**PLANNING COMMISSION
Meeting Agenda
Monday – November 9, 2009
7:00 PM - Regular Meeting
City Council Chambers – 155 NW 2nd Avenue**

STAFF REPORT

MOD 09-04

The applicant is requesting an Intermediate Modification of Site and Design Review approval no. DR-98-08 in order to change Condition #39 to reduce the amount of vehicle parking required, and to allow removal of 10 vehicle parking spaces and construction of a drive-through automated teller machine (ATM) with signage (*see Applicant's Plan - Attachment B*).

C 1.0

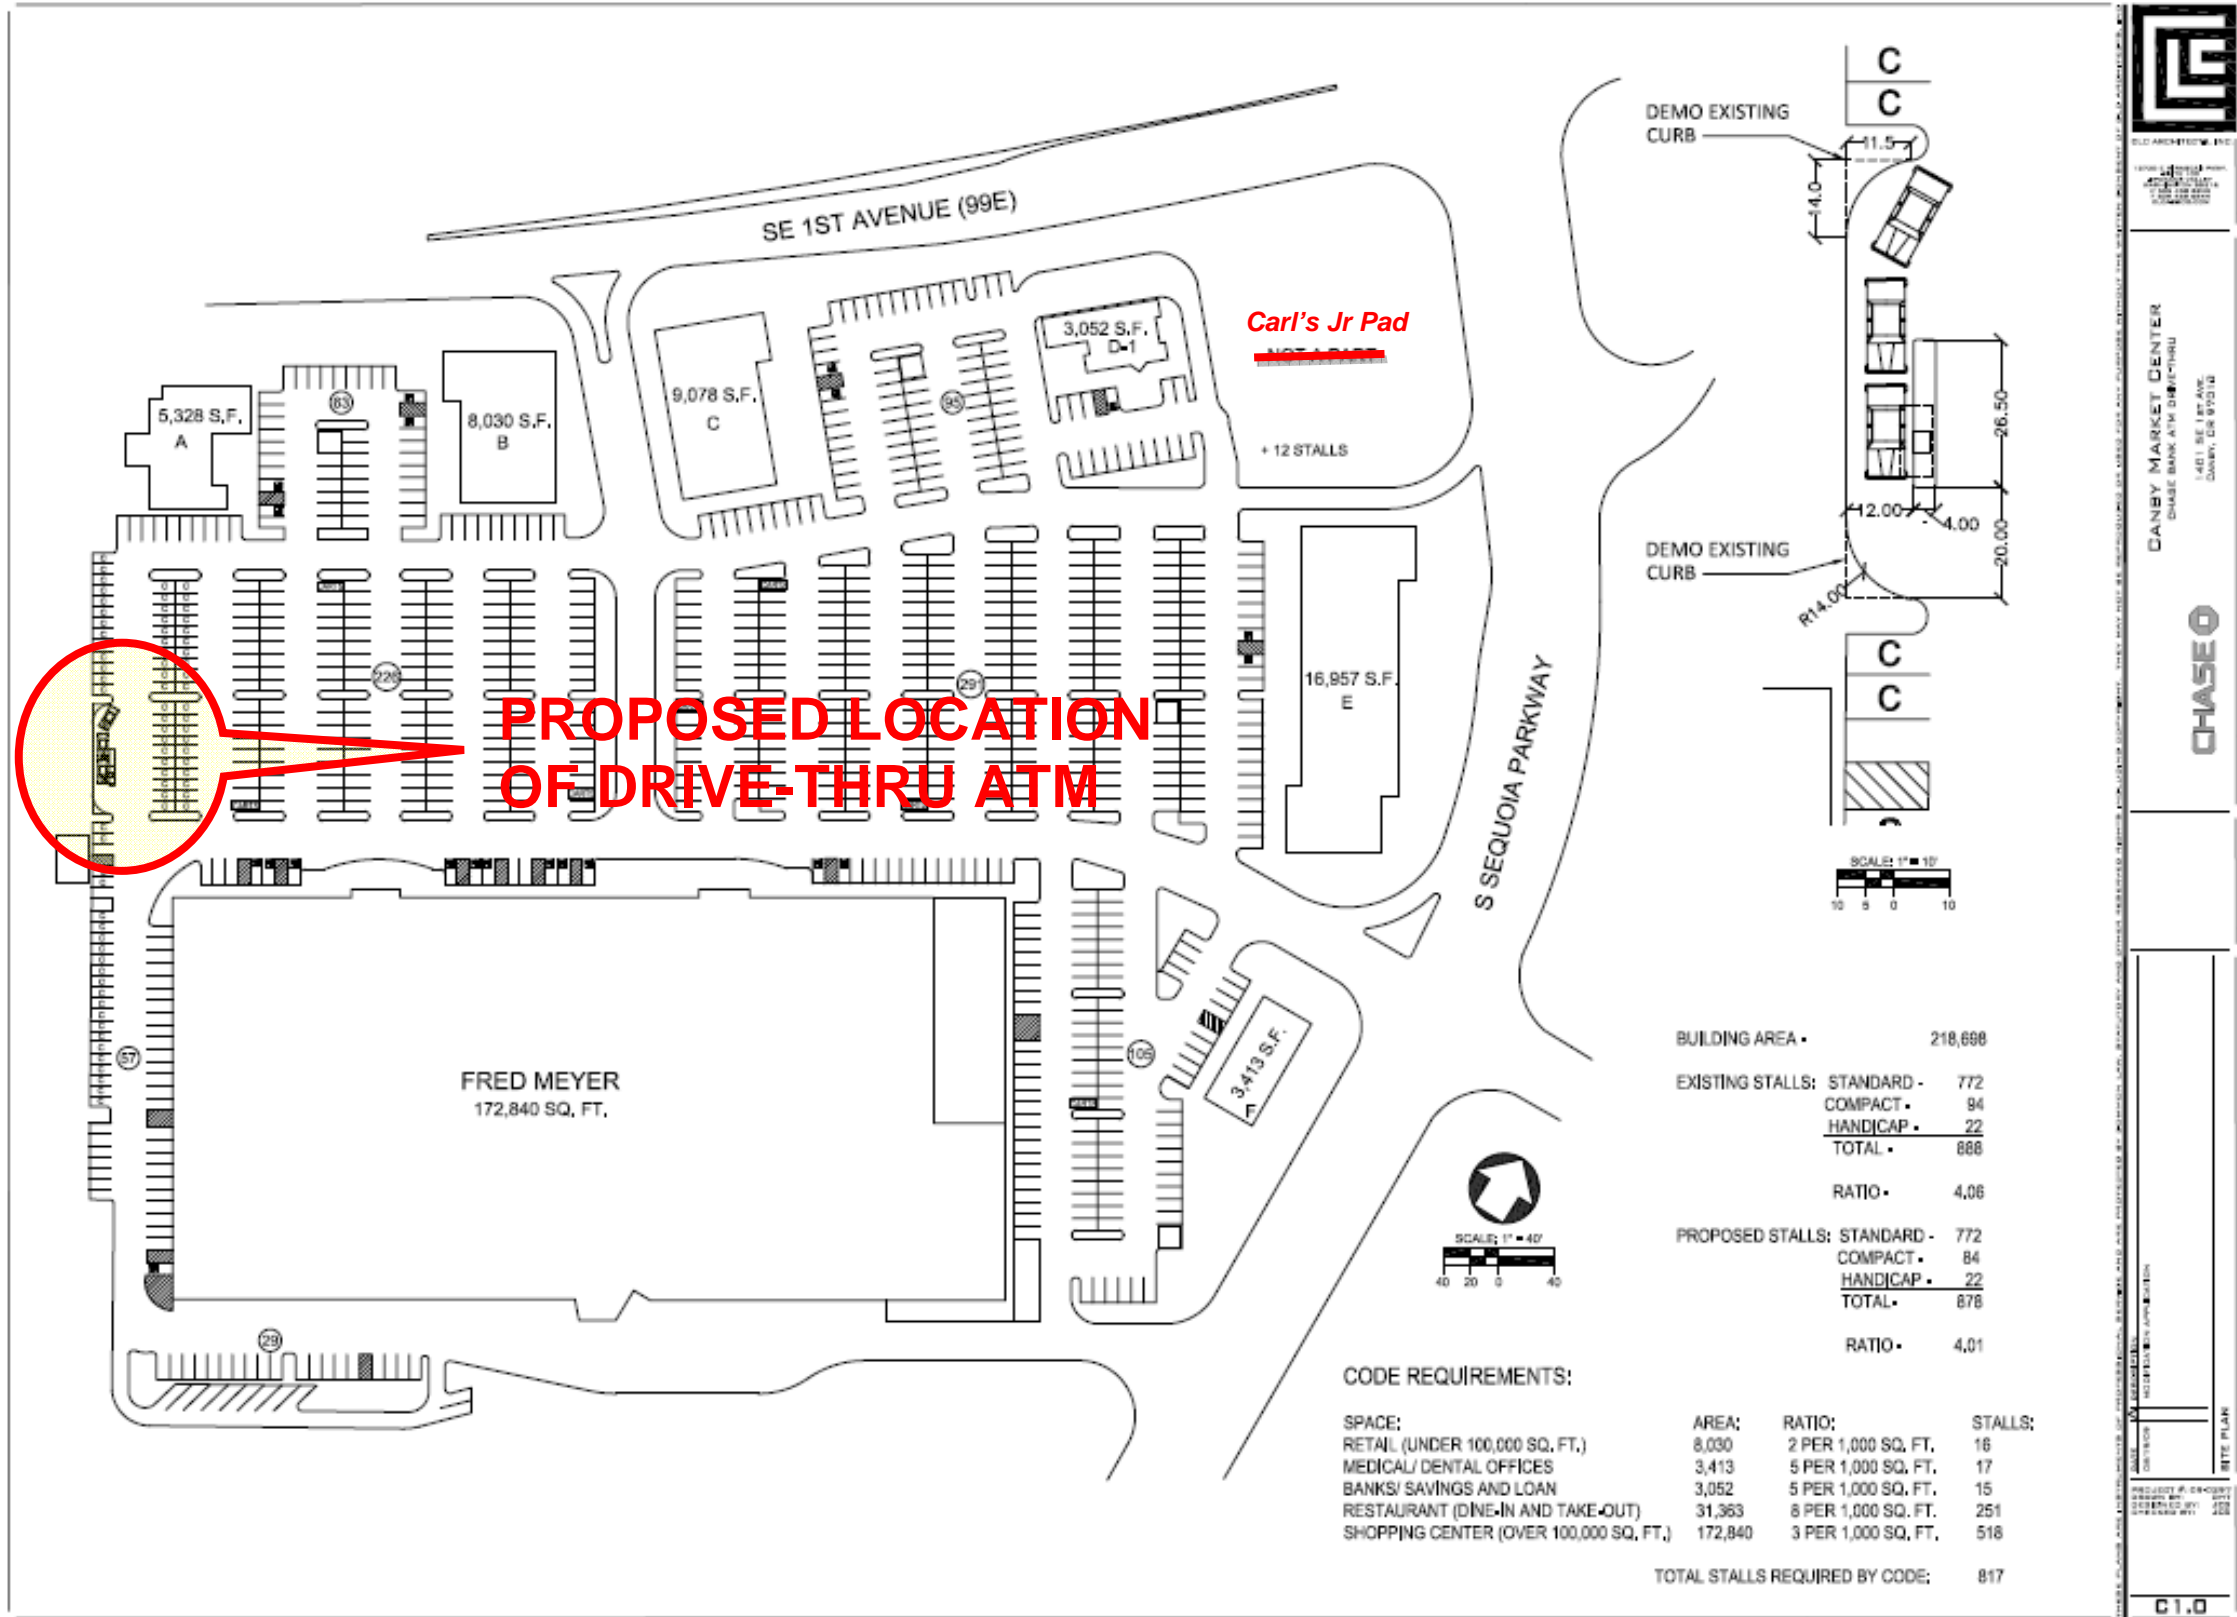
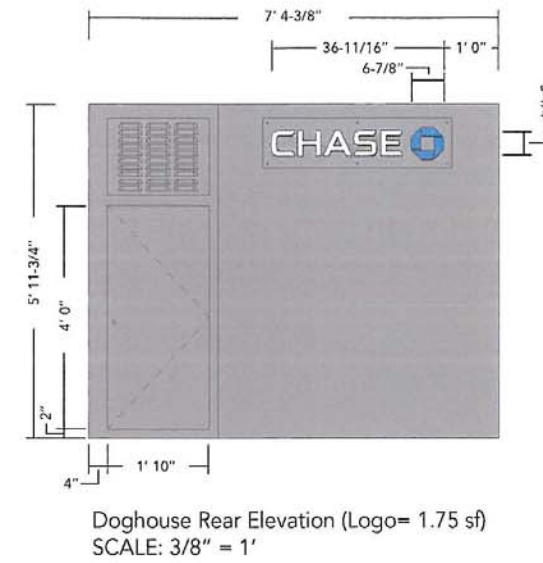
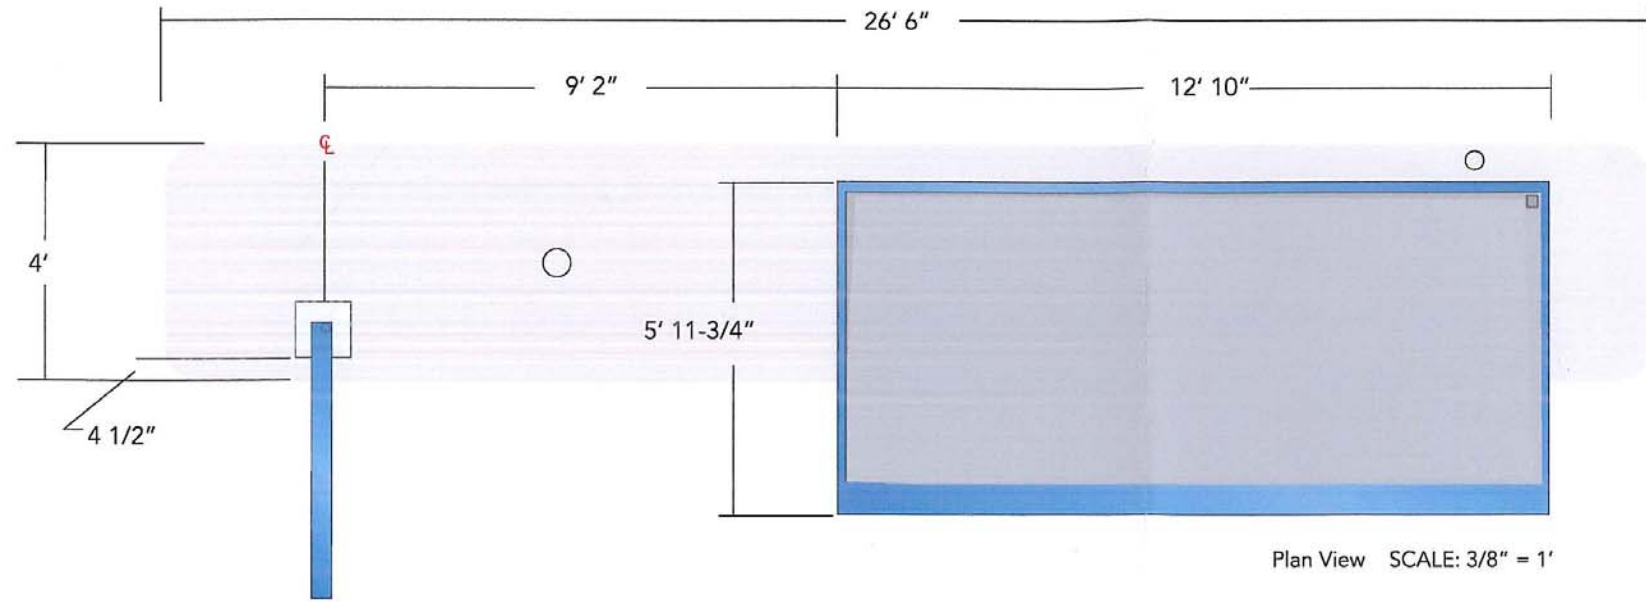
Request to construct a drive-through automated teller machine (ATM), as illustrated in Applicant's Plan (see Attachment B).

The Applicant has proposed to construct a 12'10" x 5'11-¾" ATM, located on the western edge of the parking lot, north of the bottle recycling building. The proposal includes a detached metal clearance bar, which will be located approximately 9 feet from the ATM, and two bollards, which will be located next to, on either side of the ATM. The proposal is to locate these fixtures on a 6-inch high concrete island that is approximately 26'6"x4'. The color scheme proposed for the ATM and fixtures is blue and grey, as illustrated on the applicant's attached plan. And proposed lighting consists of two metal halide downlight fixtures to be installed on the underside of the canopy. The location and orientation of the ATM and island preserve the functionality of the surrounding parking area by maintaining and not impacting the existing maneuvering aisle width, by working with the existing flow of traffic in how the vehicles are routed into the ATM access area, and by providing enough space to accommodate stacking of 3 vehicles outside of the parking lot maneuvering aisle. The proposal eliminates ten existing compact parking spaces, the impact of which is discussed on the previous page (pg. 3). And the proposal does not displace any existing landscaping area. The structures are located outside of the 10-foot minimum required setback area. And the overall height of the structure, at 9'6", is well below the maximum allowed building height of 45 feet. Staff recommends that Planning Commission find that the installation of the ATM and fixtures, as proposed, is in conformance with all the Site and Design Review approval criteria, and with all other applicable city ordinances.

APPLICANT'S PLAN (cont.)

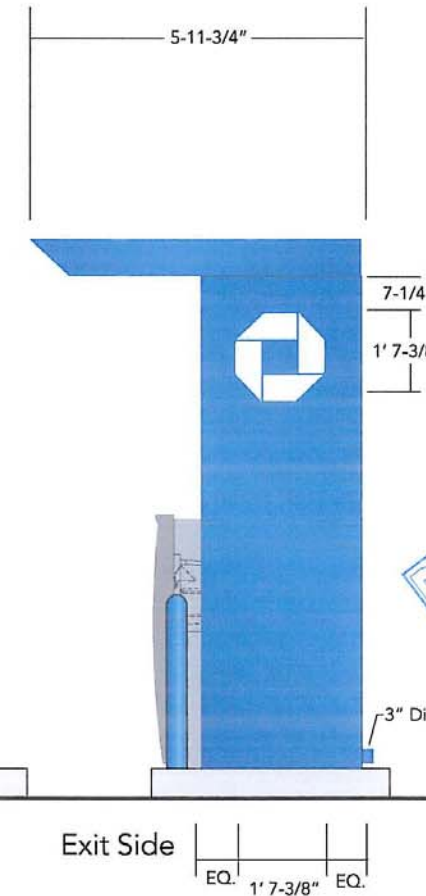
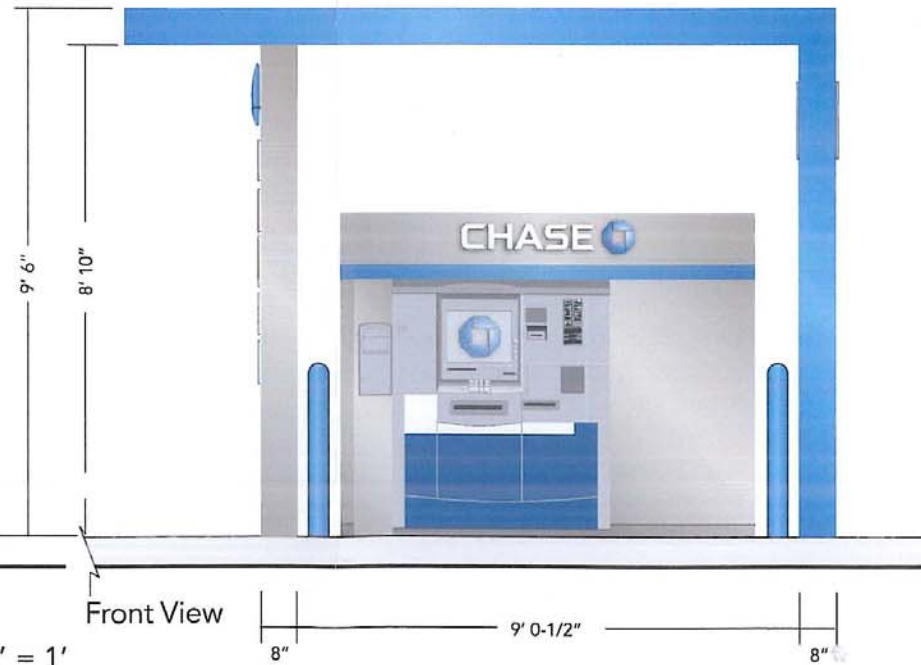
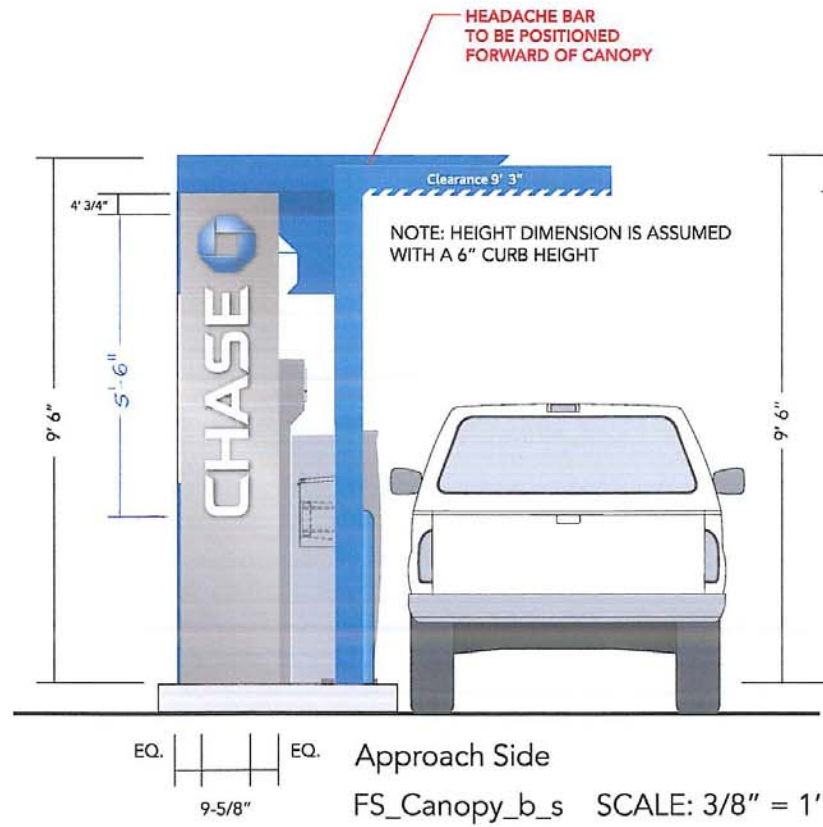
Request for signage, as illustrated in Applicant's Plan (see Attachment B).

The Applicant has proposed internally illuminated halo-lit LED signage for all four sides of the ATM. However, the signs do not meet the definition of any of the types of signage allowed in the Canby code, because the ATM structure is not a "building", and the regulations do not specifically address signage on a non-building type structure, such as an ATM. Therefore, staff recommends that Planning Commission review the proposed signs to determine, "Are they similar enough to a wall sign that we can allow them?," and, since the wall sign regulations concerning size of signage allowed on a building were not written in a way that they can be easily applied to signage on a mechanical structure (e.g., size of wall signs can be up to 6% of the building elevation area of a secondary building frontage), then "Does the signage proposed meet the purpose of Canby's sign regulations?"

Staff recommends that Planning Commission find that the proposed ATM signage is similar enough to a wall sign that it should be considered a permitted type of signage, and should therefore be allowed. And staff furthermore recommends that Planning Commission find that the size, location, and appearance of the proposed ATM signage meets the intent of Canby's sign regulations, as detailed in the following CMC Chapter 16.42 purpose statements:

- (3) *Signage permitted on the ATM shall be as detailed in the November 09, 2009, staff report, and Exhibit B thereto.*
- (4) *Condition #39 of DR-98-08 is hereby modified to read as follows: "The Planning Commission permits a minimum of 3 vehicle parking spaces per 1,000 square feet of floor area for this development."*

FIGURE
1

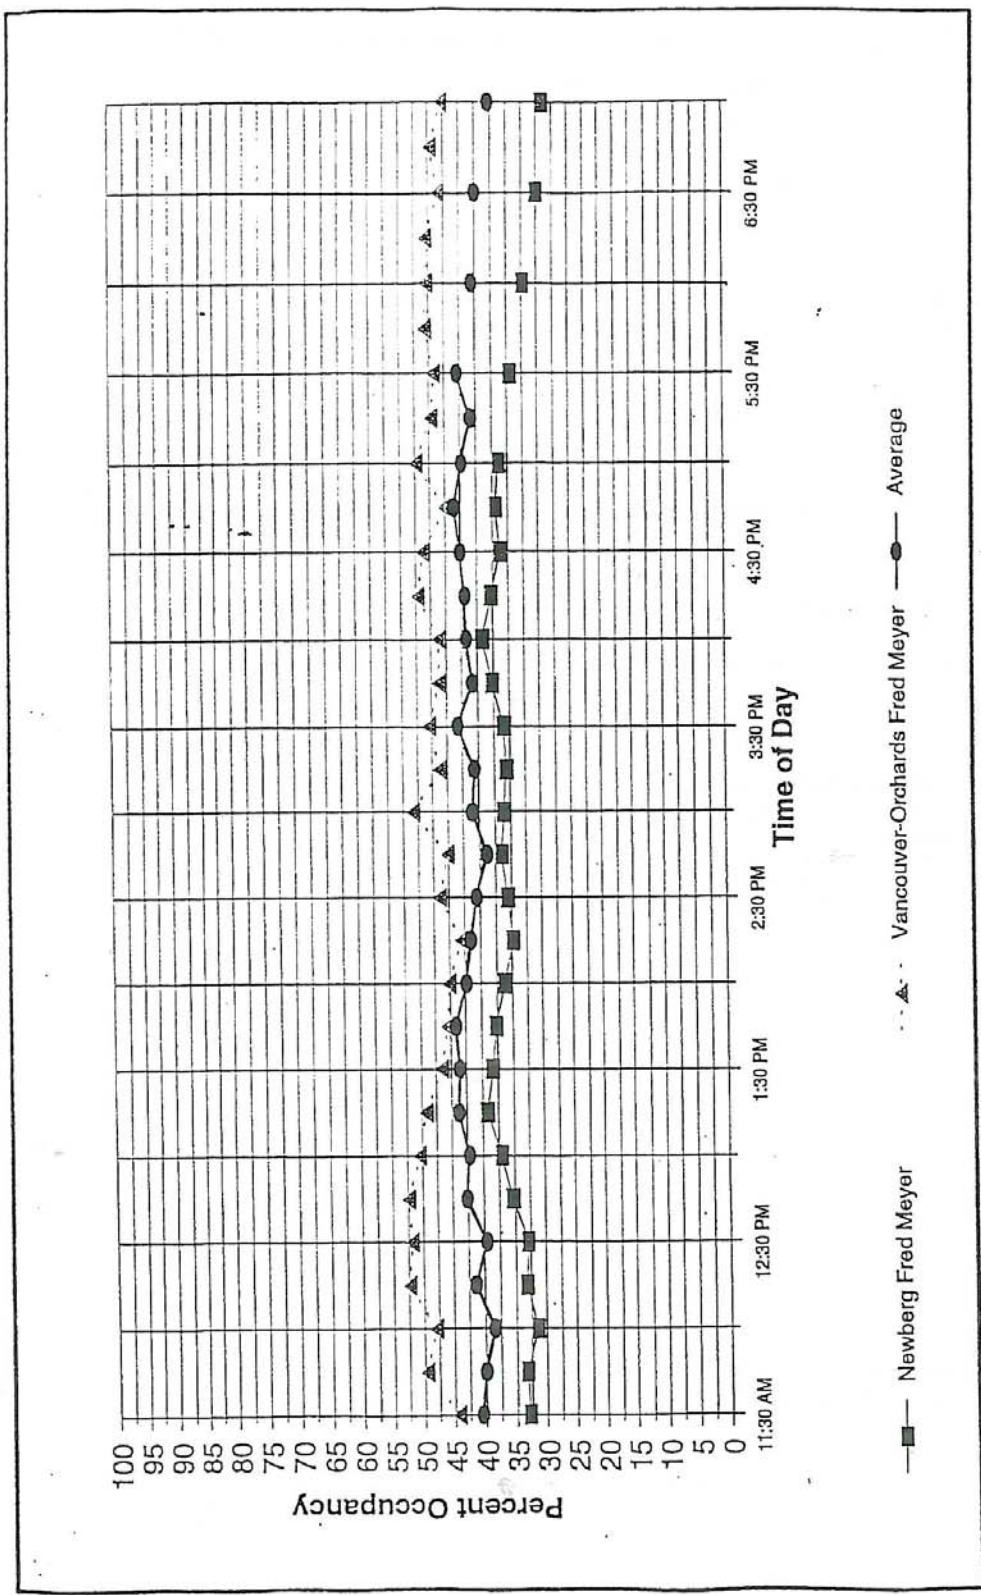
As shown in Figure 1, it was found that the peak parking period varied at the two retail centers but was generally experienced between the hours of 12:15 and 1:15 p.m. and 4:00 and 5:00 p.m. Compared to the Newberg retail center, the Vancouver-Orchards site tended to peak more closely with traffic that could be attributed to lunch and dinner traffic associated with the Shari's restaurant and Baskin Robins.

As shown in Figure 1, the Newberg retail center parking facilities peaked at 39 percent occupancy, while the Vancouver-Orchards site reached up to 52 percent occupancy of the available parking spaces. By late evening (7:00 p.m.), a sustained drop in parking demand had been observed at both of the sites as evidenced by the downward trends shown in Figure 1.

While Figure 1 shows both study site operating at approximately half of capacity, it should be noted that this data represents a typical weekday during the month of July. Parking demands during July are approximately 75%¹ of those experienced during the holiday season (November and December), and weekday parking demands are approximately 80%² of the weekend demand generated at retail shopping centers. Therefore, the parking demands measured in the field and documented within Figure 1 represent only 60% of the parking lot design demand.
